Pre-Application Report

Case Number / AMANDA No. 22-102664-PA / PRE-AP22-09

Project Description	Pre-application conference to discuss a proposed Class 1 Design Review, Class 3 Site Plan Review, Class 2 Adjustments, and Class 2 Driveway Approach Permit for a 94 unit apartment complex on 3.25 acre Parcel 2 of Partition Plat No. 2021-64 within a 3.54 acre territory that is being annexed with a Multi-Family Salem Area Comprehensive Plan Designation and RM2 (Multiple Family Residential 2) zoning.
Property Address	3476/3480 Blossom Drive NE 97305 (Attachment A)
Assessor's Map and Tax Lot Number	Marion County Assessor Map and Tax Lot 073W01A03300
Existing Use	Single family dwelling and accessory structures
Legal Units of Land	The parcels were created through a Marion County partition process – Partition Plat No. 2021-64.
Comprehensive Plan Map Designation	MFR - Multi-Family Residential
Urban Service Area	The subject property is located outside of the City's Urban Service Area.

- 1 HORIZONTAL LAPPED FIBER CEMENT SIDING, 6'
EXPOSURE, COLOR: PEPPERCORN, SW7674
- 2 HORIZONTAL LAPPED FIBER CEMENT SIDING, 6'
EXPOSURE, COLOR: CLASSIC FRENCH GRAY, SW0077

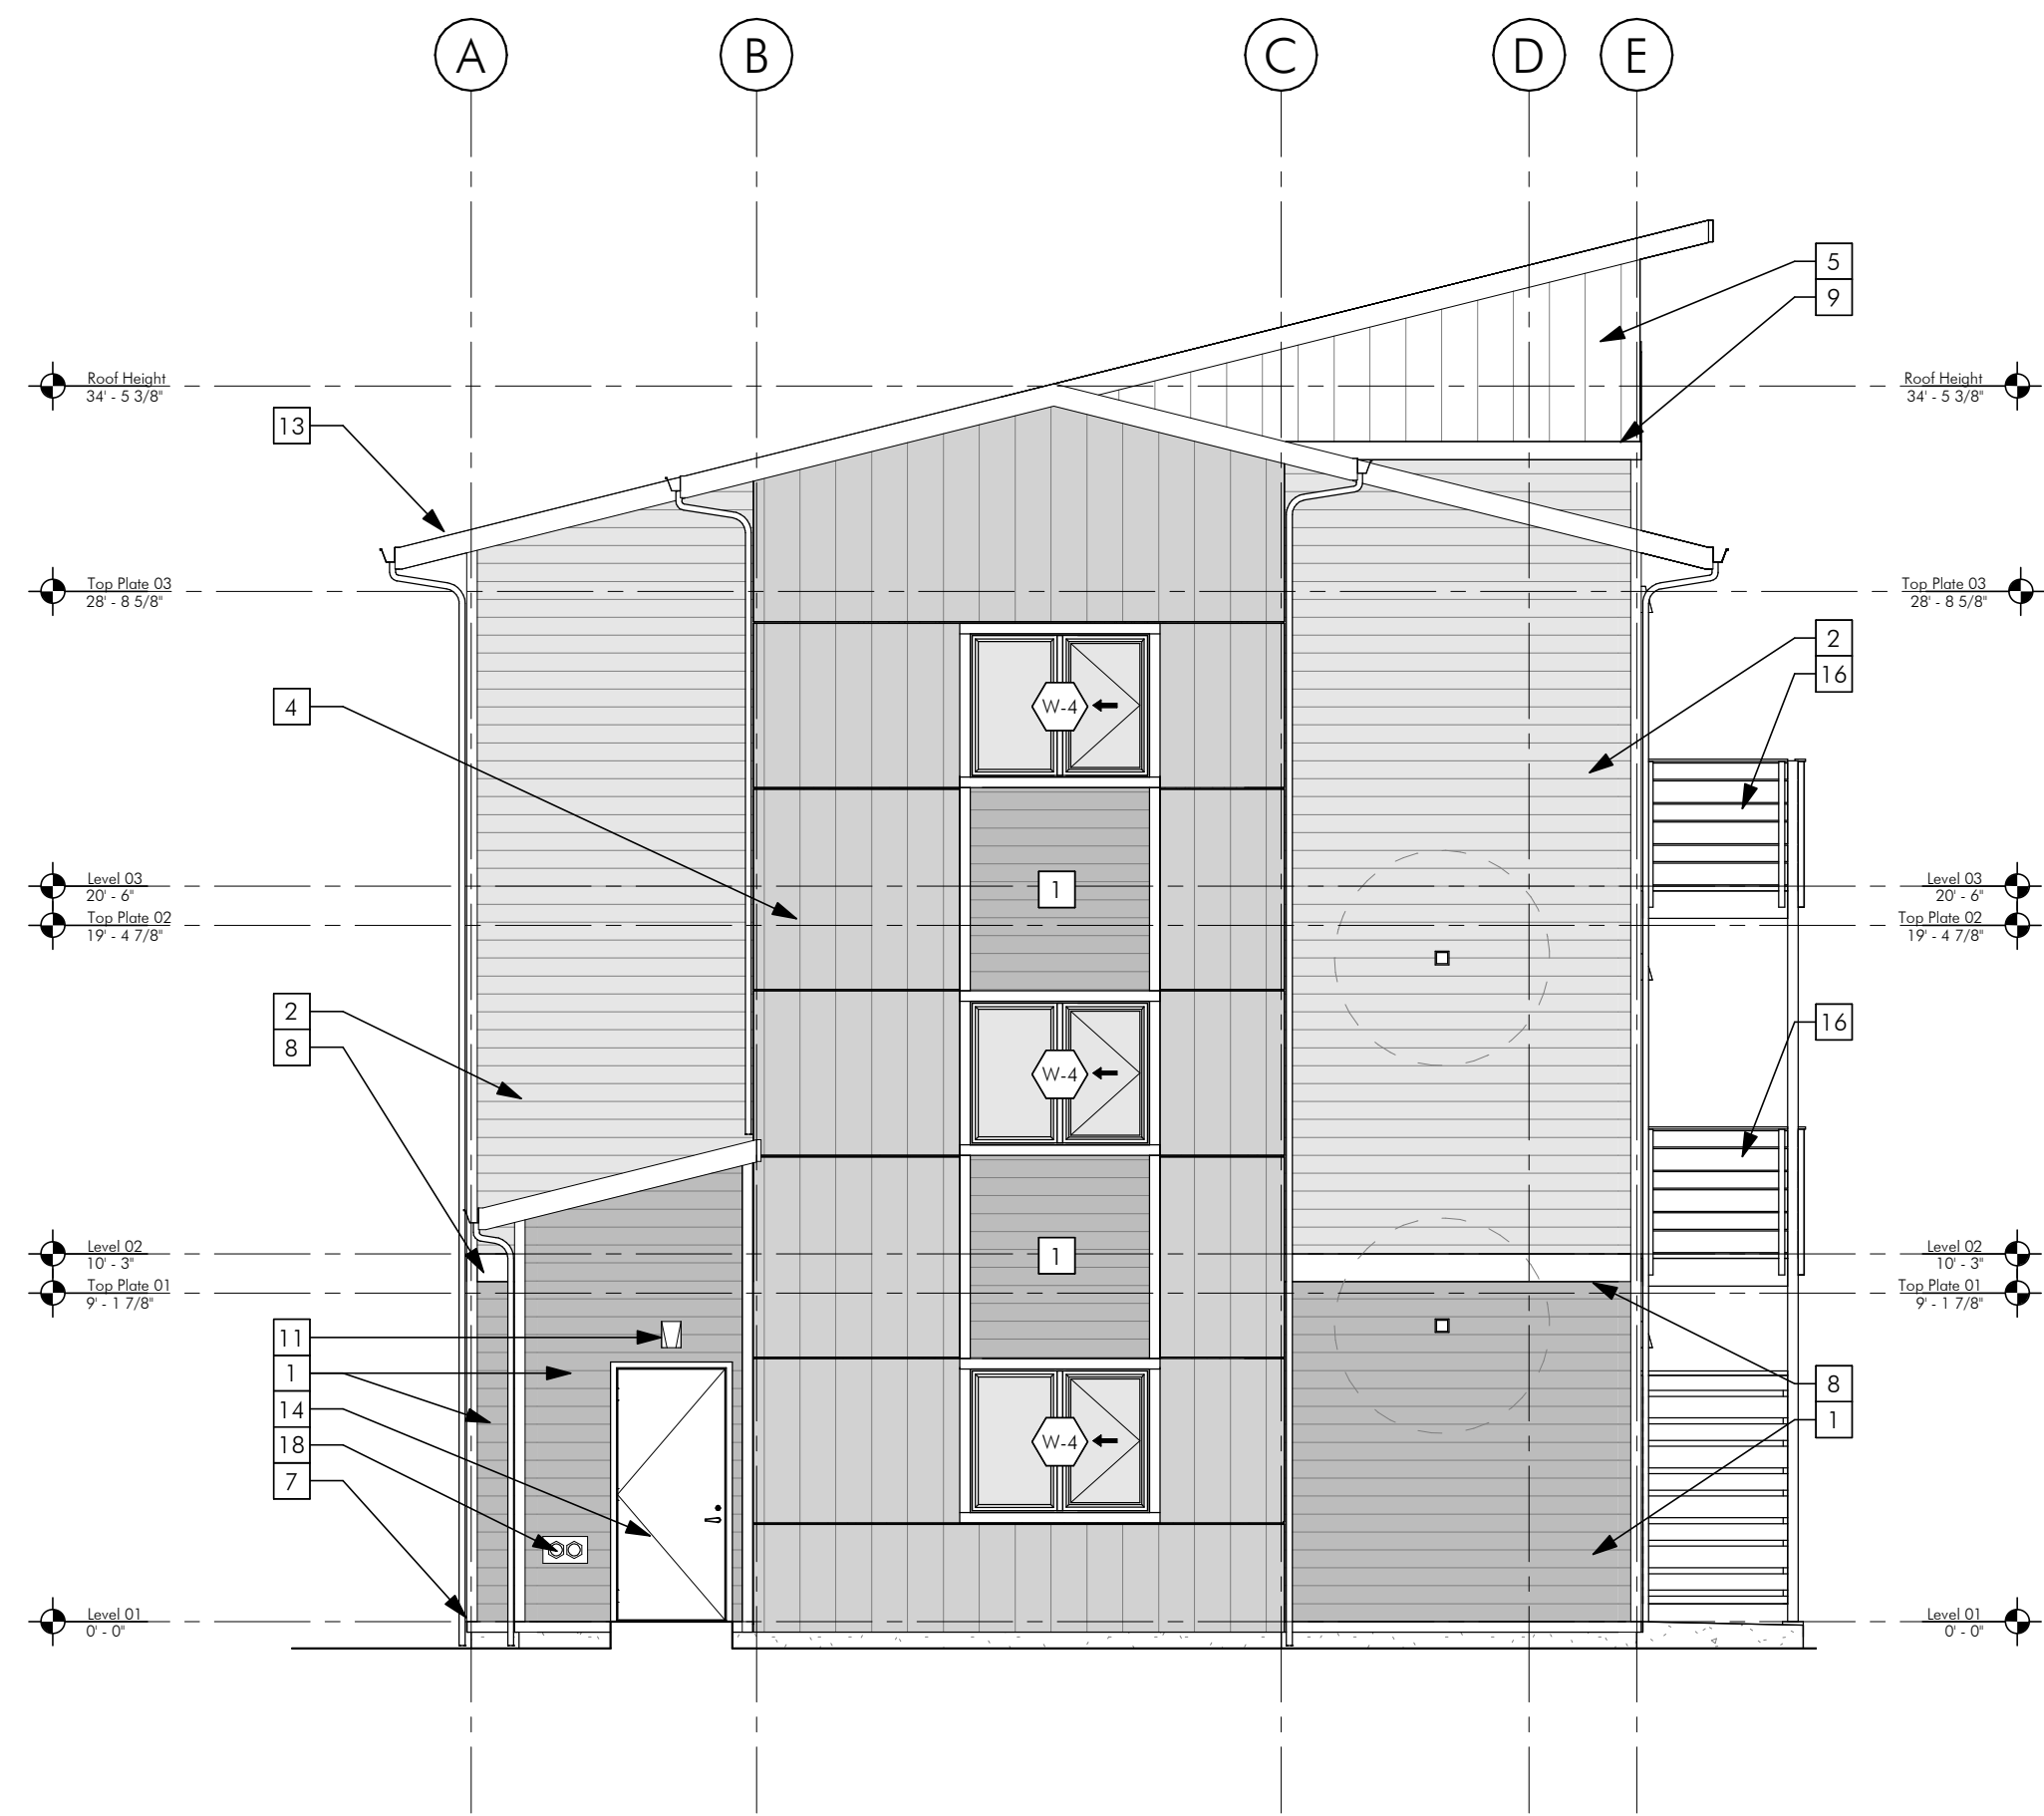
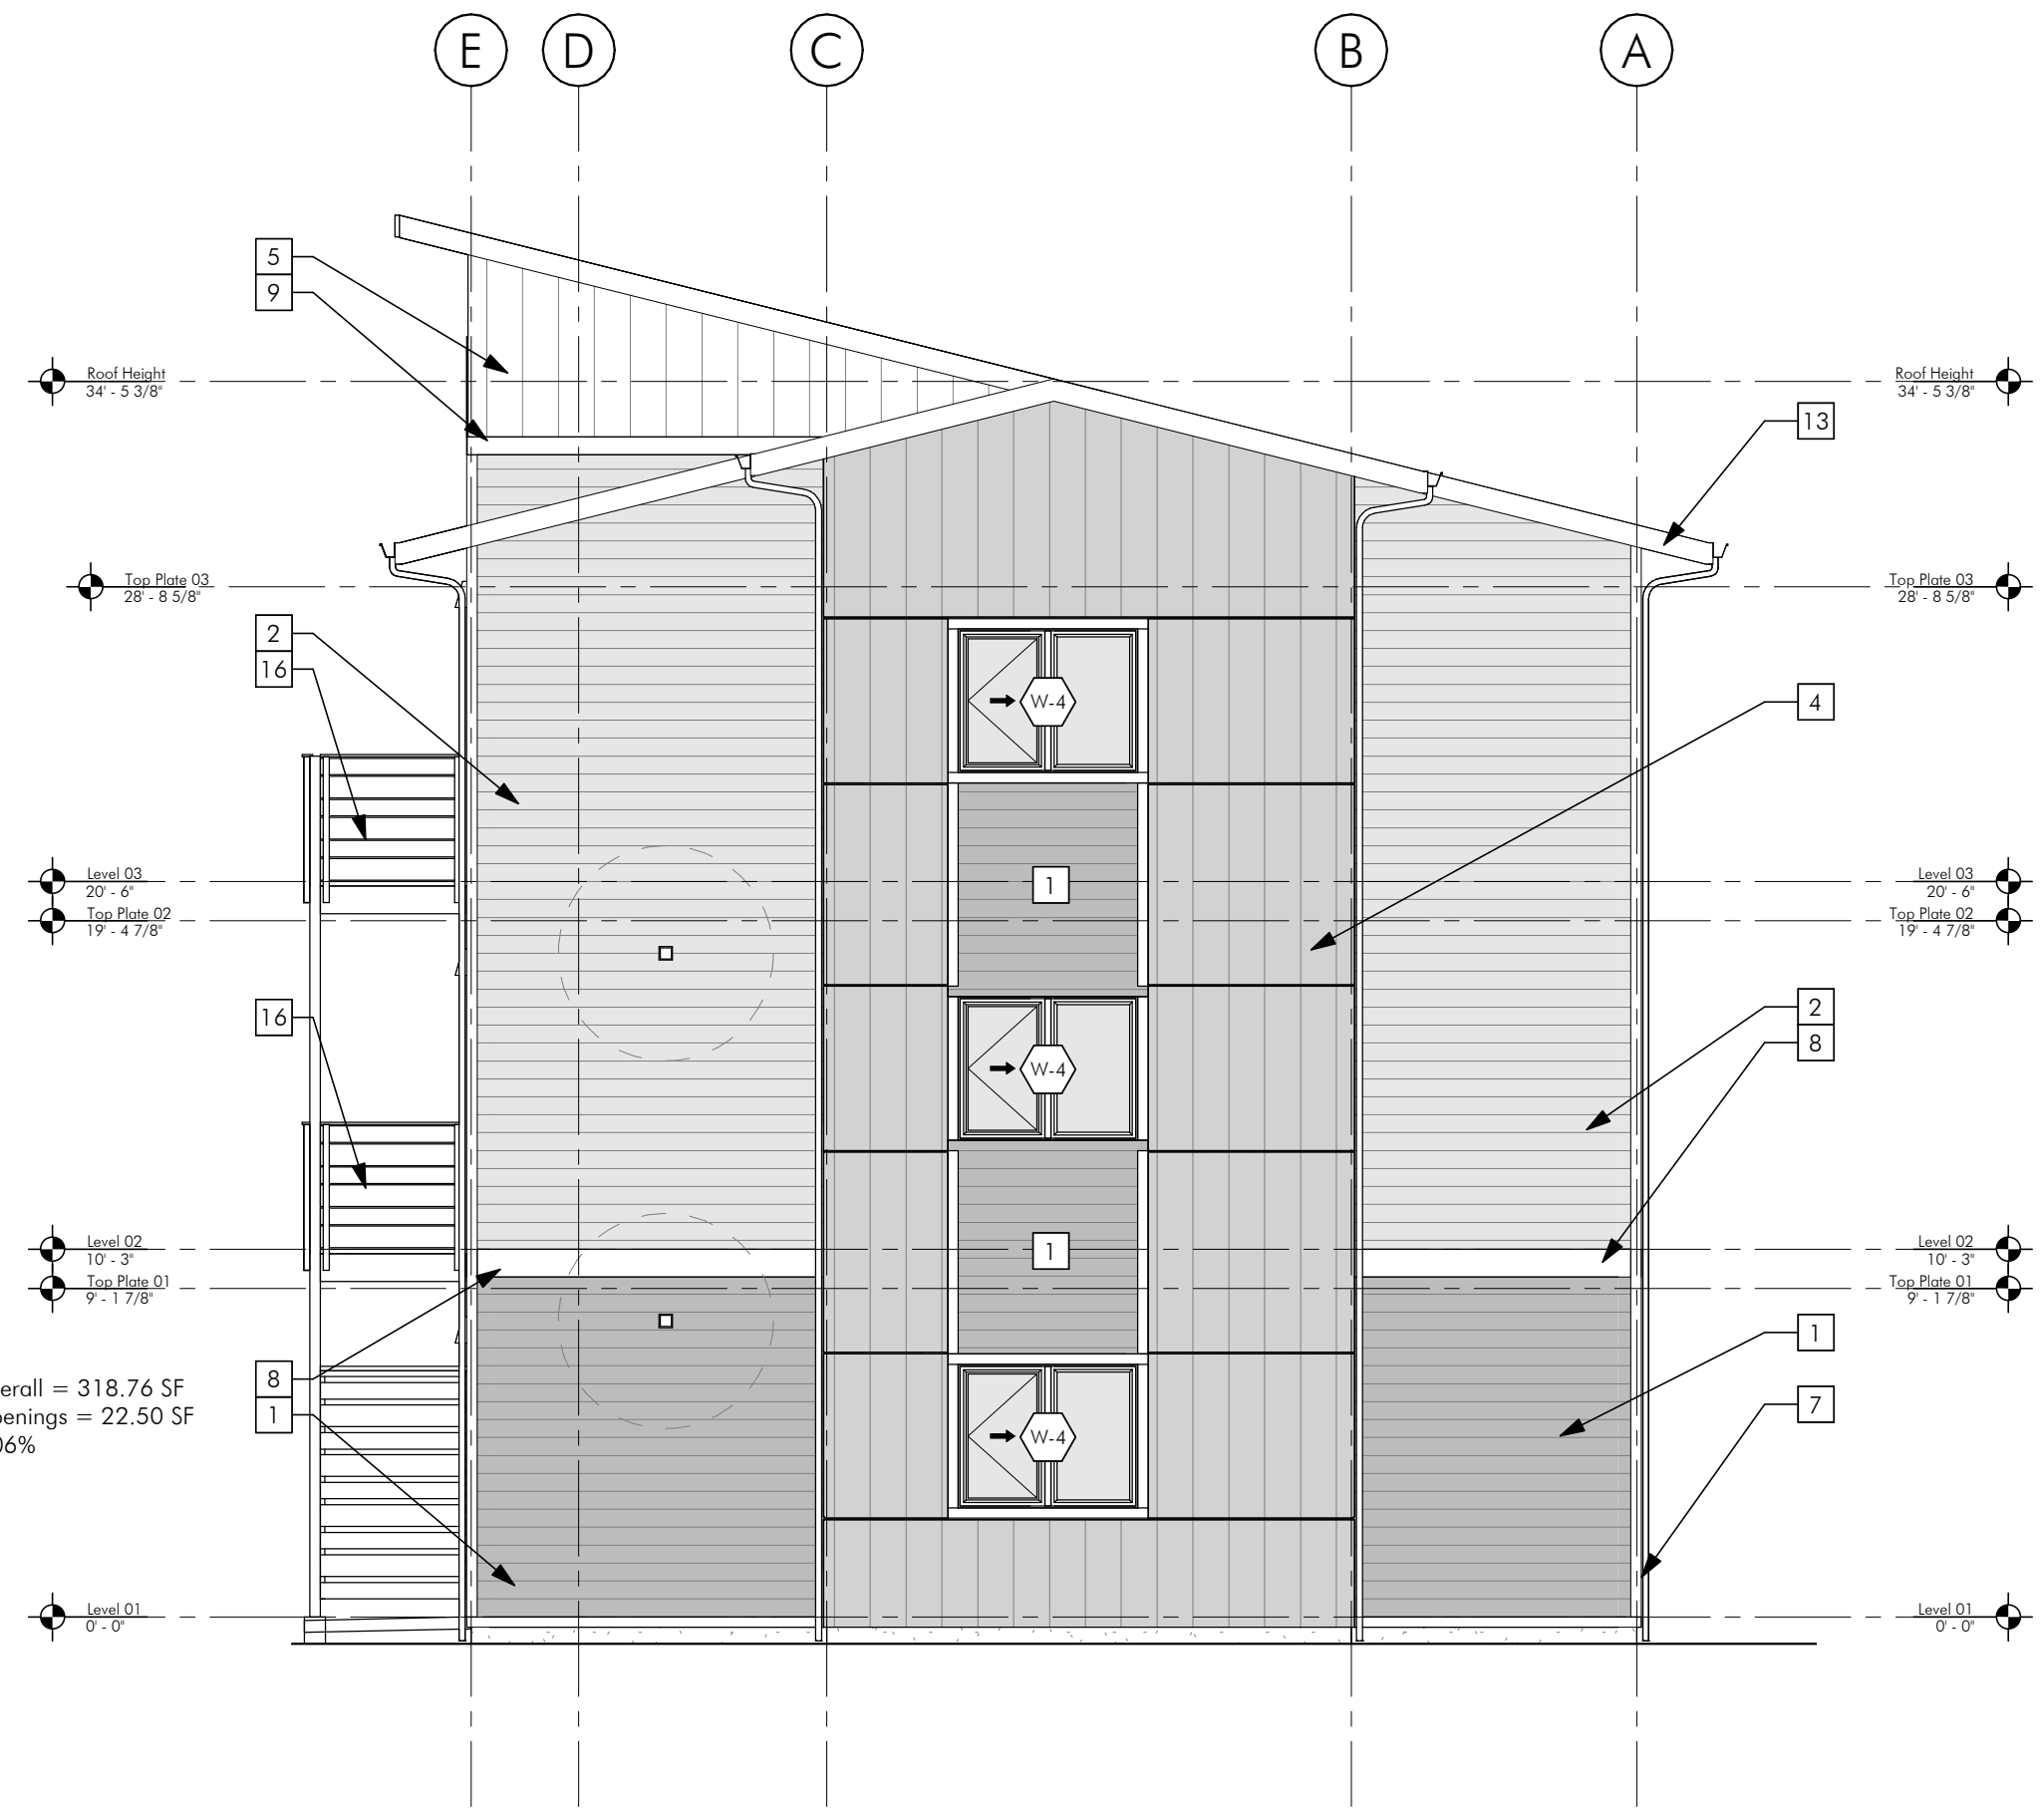
Staff response: *Standard 5 applies to any building located near the street, not only to the buildings with apartments. Staff cannot determine whether the outward-facing elevations meet standard 9, which applies to all vertical faces 80 feet or longer, because these faces are shown on the site plan as continuous lines exceeding 125 feet in length. When the site plan is reconfigured and the elevation drawings are submitted, please demonstrate compliance with the standards.*
